Staff Report

From: Dan Handel, AICP, Planner

Meeting Date: November 10, 2022 (Prepared November 3, 2022)

Item: DR 22-05, EXCP 22-07, & VAR 22-06 “Woodburn Apartments” at 119 N. Pacific Highway

Figure 3.01B – Major Arterial

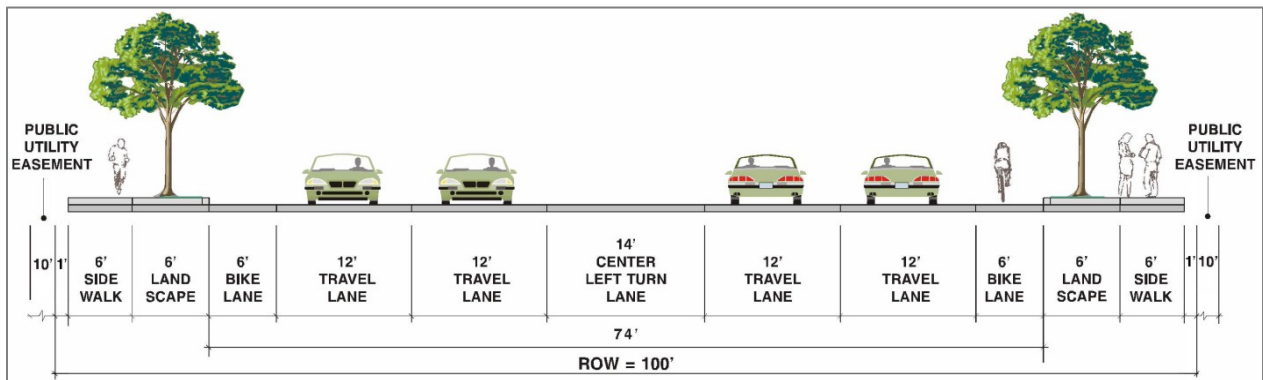
The proposal is new construction of a multifamily residential apartment building, which is “development” per subsection D, therefore the provisions within 3.01 apply.

The subject property has frontage along N. Pacific Highway, a public street. Figure 2 of the Transportation System Plan illustrates it is a Major Arterial street, for which the associated WDO cross-section is Figure 3.01B.

Figure 3.01B – Major Arterial

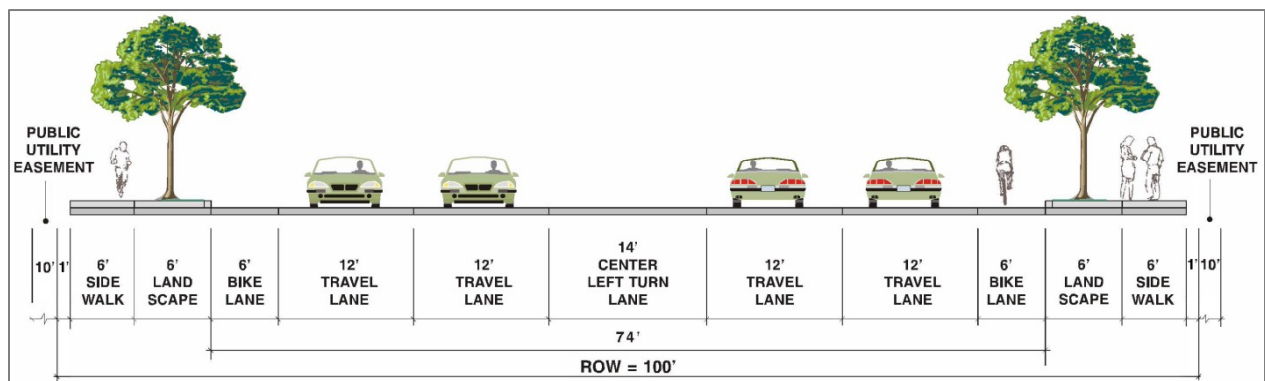
Applicant's response: "Due to the location of the railroad crossing and existing improvements to the north and south, a Type III design exception request will be submitted to maintain the existing curb location on N Pacific Hwy and install a 8' wide sidewalk in lieu of bicycle lane per WDO Dated June 12, 2022. N Pacific Hwy is classified as a Major Arterial which includes a center turn lane, two lanes of directional travel, bike lanes, landscape, and sidewalk. The road currently contains the center turn lane, two lanes of travel in each direction, and curb. There are no bike lanes to the north or south of the project. The required ROW will be dedicated for future expansion of the existing highway, but the existing curb will remain to more easily tie into the existing road. The 8' wide sidewalk will be installed in the location assuming the street was fully built-out to avoid the sidewalk being demolished with future road improvements. The sidewalk will connect to the existing asphalt pedestrian connection located at the south corner of the lot and be stubbed to the north. There is no existing pedestrian access along the property to the north's frontage. Since the road is existing and includes the travel lanes, there are no anticipated impacts to traffic, the building, or pedestrians to leave the curb as is."

As noted in the analysis for 3.01, N. Pacific Hwy is a Major Arterial street and the applicable cross-section is Figure 3.01B. Existing right-of-way width appears to be 80 feet. Existing curb-to-curb conditions along the site frontage include two travel lanes in each direction, a center turn lane that tapers to the south due to the railroad crossing, and no bike lanes. There is no existing landscape strip or sidewalk along the site frontage.

The proposed sidewalk is 8 feet wide in order to function as a shared bike and pedestrian path. The existing curb-to-curb improvements provide for vehicular travel consistent with the Major Arterial cross-section, while also accounting for the proximity of the railroad crossing.

Staff adds *Condition of Approval 6* to outline the modified street improvement requirements and specify when such improvements must be completed.

1 SITE PLAN
 0 4 8 16 24 48
 1/16" = 1'-0"

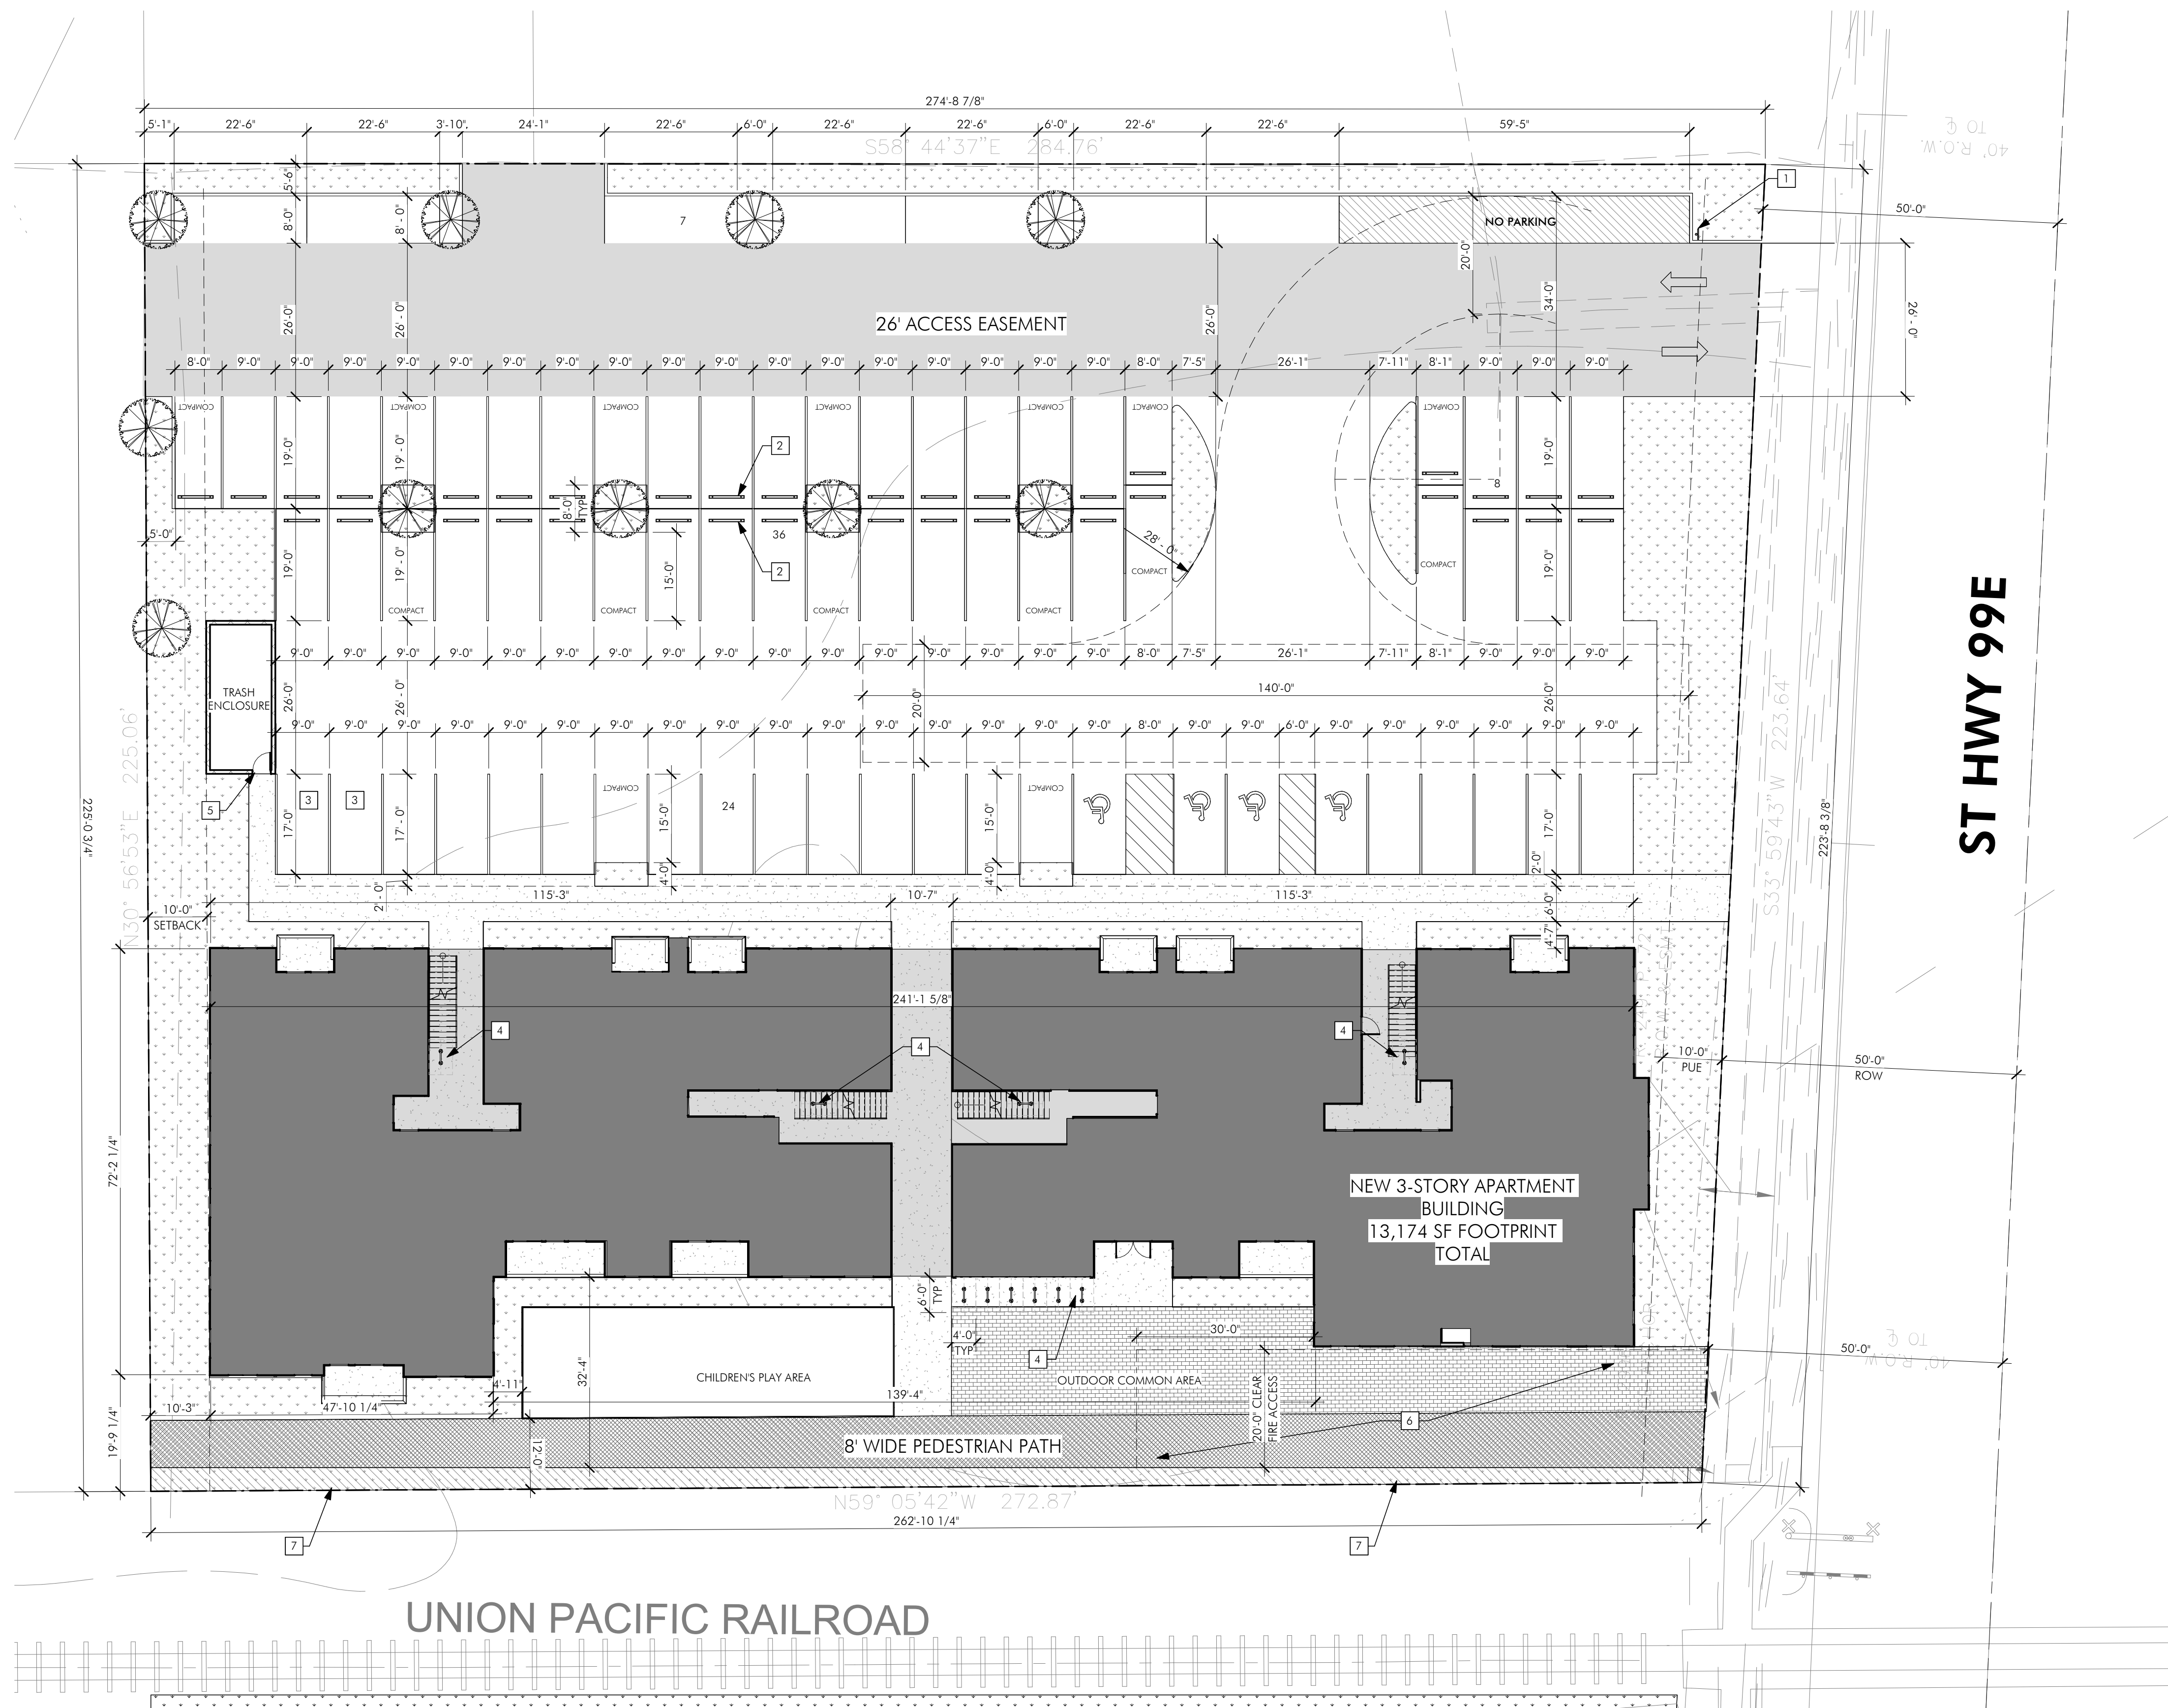
The minimum parking requirement is 70 spaces and maximum allowance is 140 spaces. Plans show 75 spaces are provided, 13 of which are compact. Four accessible spaces are provided; staff adds *Condition of Approval 11* to note one of the accessible spaces shall be "Van Accessible".

Plans illustrate parking stalls in the 0-degree and 90-degree configuration. Stalls are shown to meet the dimension requirements in Table 3.05C and 26-foot drive aisles are provided.

Adjacent properties surrounding the subject property are within the CG or MUV zones therefore no perimeter screening is required by Table 3.06D. Sheet A1.01 notes a 6-foot tall cedar fence is proposed along the south property line.

The site plans illustrate an outdoor trash enclosure, which is required by Table 3.06D to be enclosed within an architectural wall at 6-7 feet tall. Staff adds *Condition of Approval 13* to meet this requirement.

Plans also show a retaining wall proposed on the south side of the pedestrian path along the south property line, but no design details are provided. Staff adds *Condition of Approval 14* to provide these details to ensure conformance with 3.06.06B.

PRELIMINARY
PLANTING
PLAN

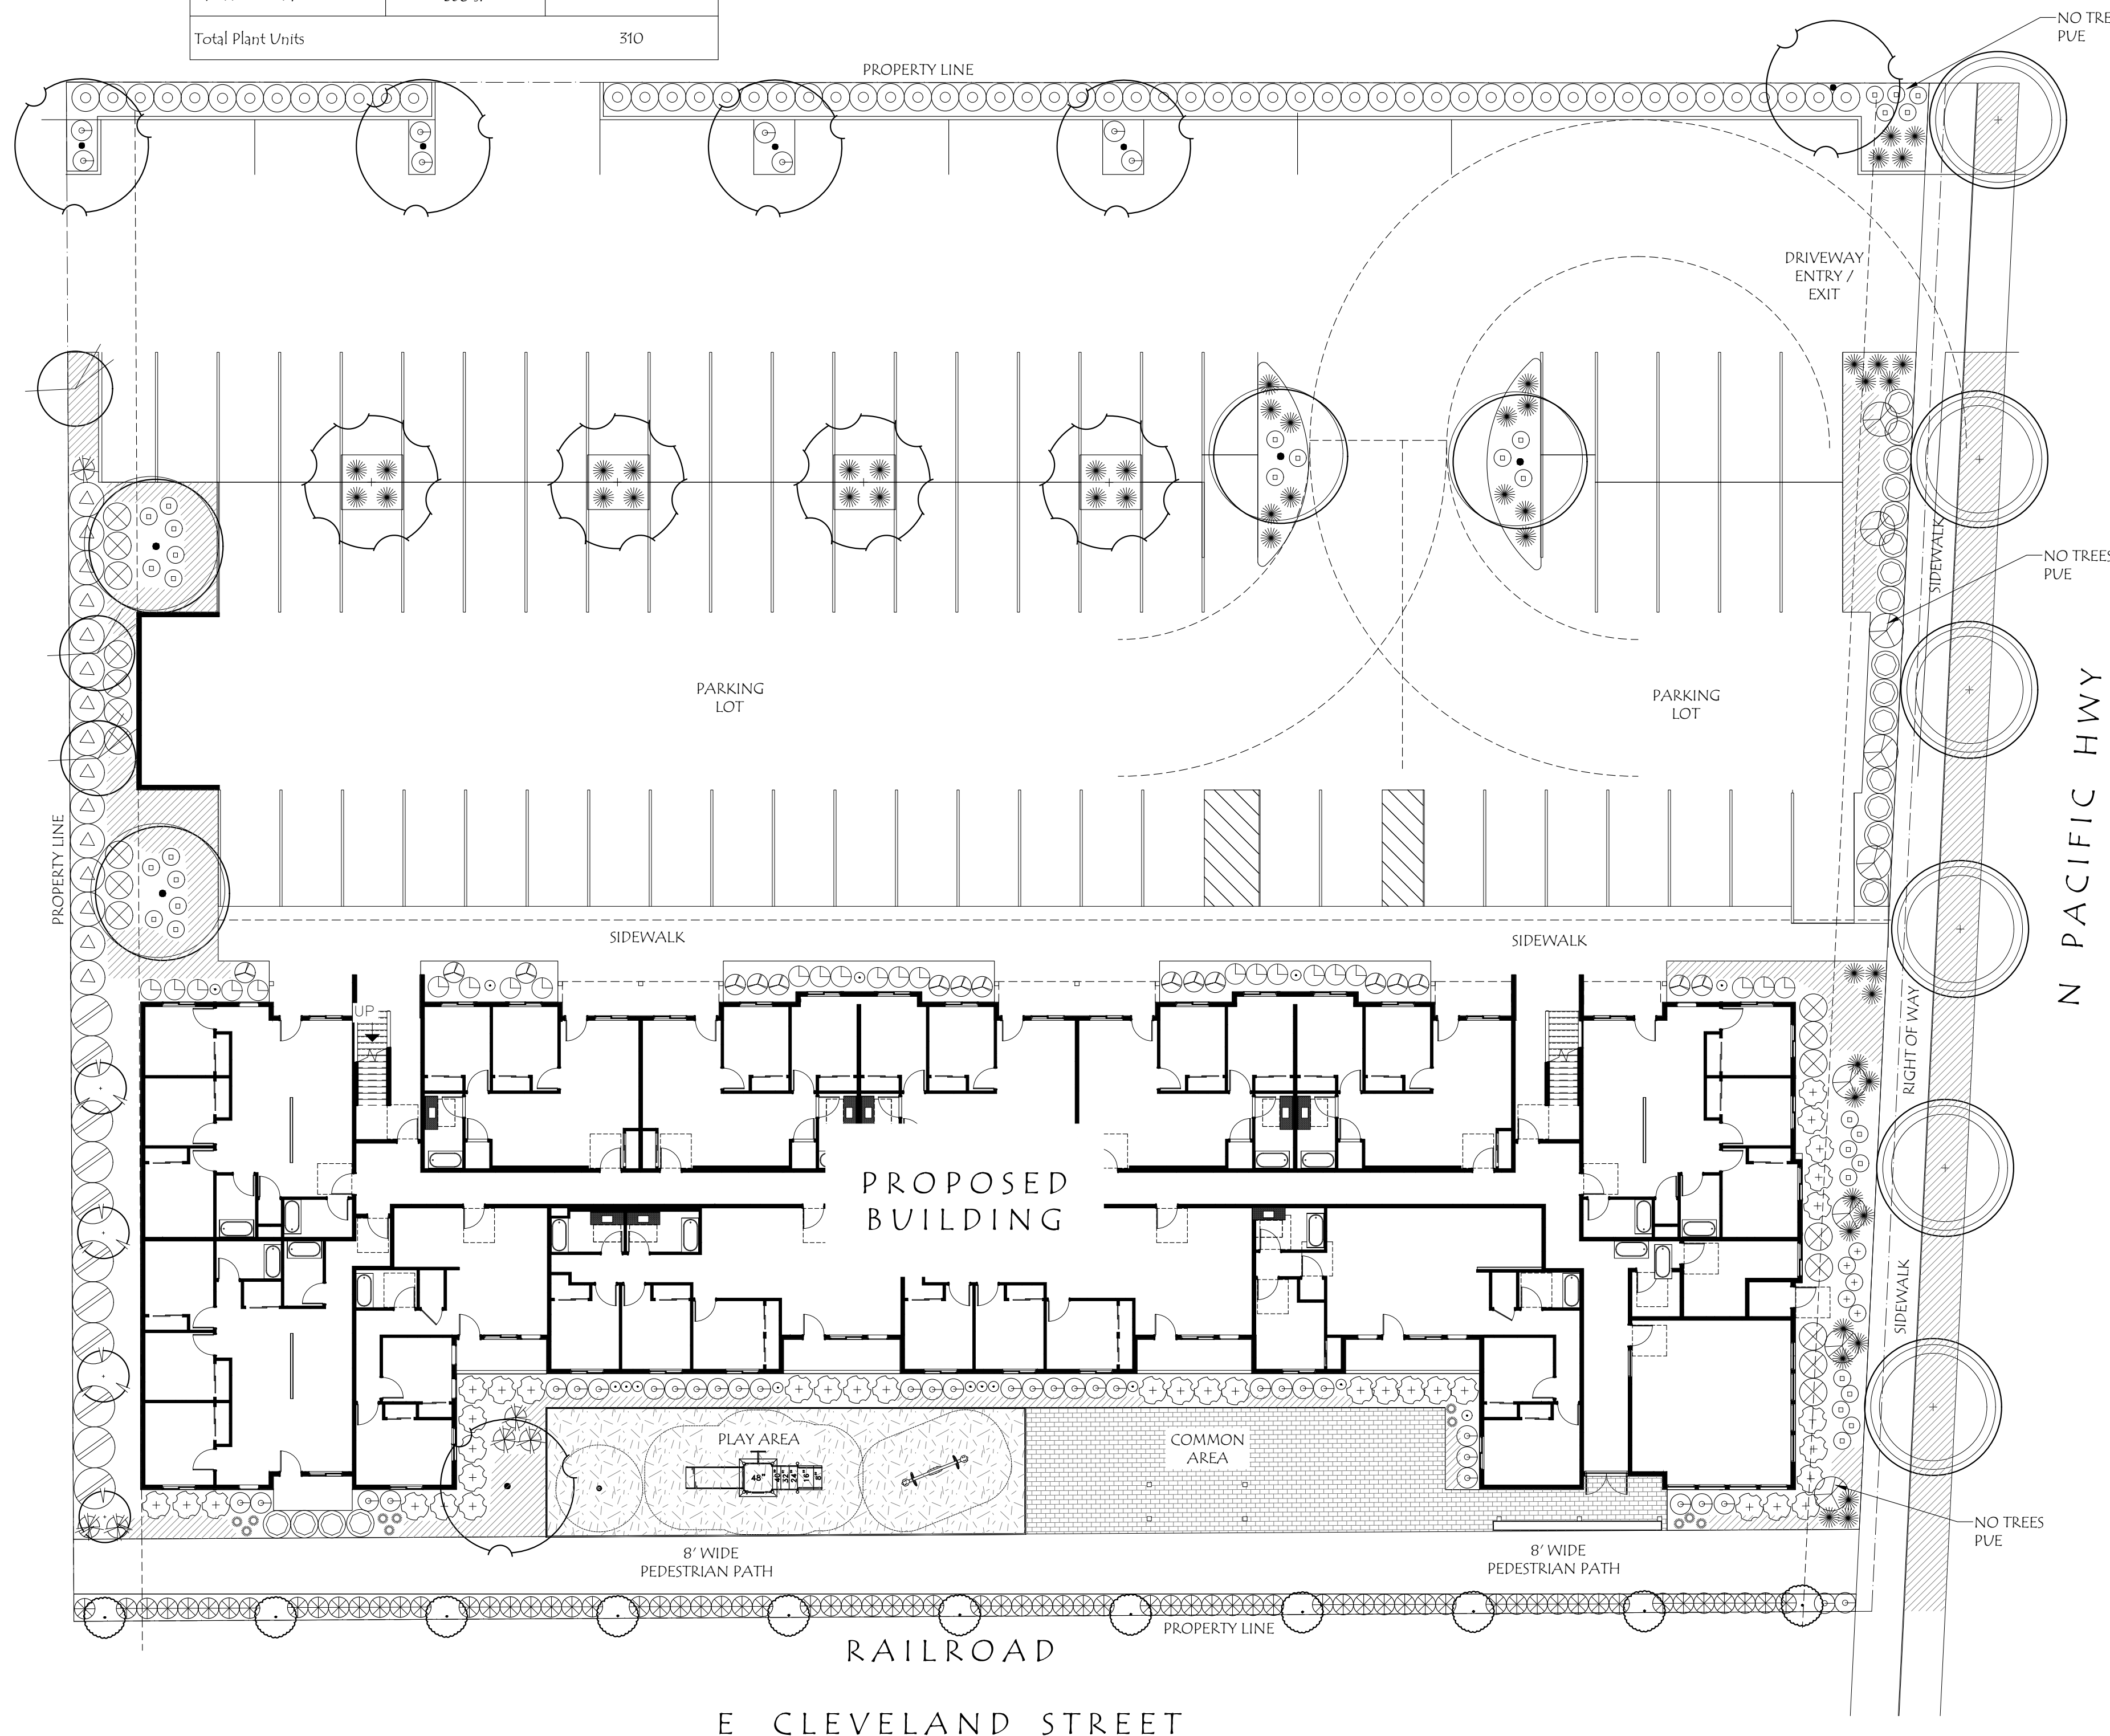
Regarding street trees, there is approximately 223 feet of frontage therefore a minimum of four large street trees are required. The landscaping plans illustrate six proposed street trees. Because staff received direction from the City Engineer that trees are not allowed within the landscape strip along this property frontage of N. Pacific Hwy due to the proximity of existing underground utilities, staff adds *Condition of Approval 6d* to instead provide landscaping within the landscape strip at a ratio of 1 Plant Unit per 15 square feet, following the “Setbacks abutting a street” yard type within WDO Table 3.06A.

- d. **Landscape strip:** Pursuant to WDO 3.06.03A3, the applicant shall revise the landscape plans to remove the six proposed street trees within the landscape strip area between sidewalk and curb. This area shall instead be planted at a ratio of 1 Plant Unit per 15 square feet, following the "Setbacks abutting a street" yard type within WDO Table 3.06A. Plant Unit values are outlined within Table 3.06B. Trees are not allowed within this landscape strip. Provide a revised landscaping plan that demonstrates conformance.
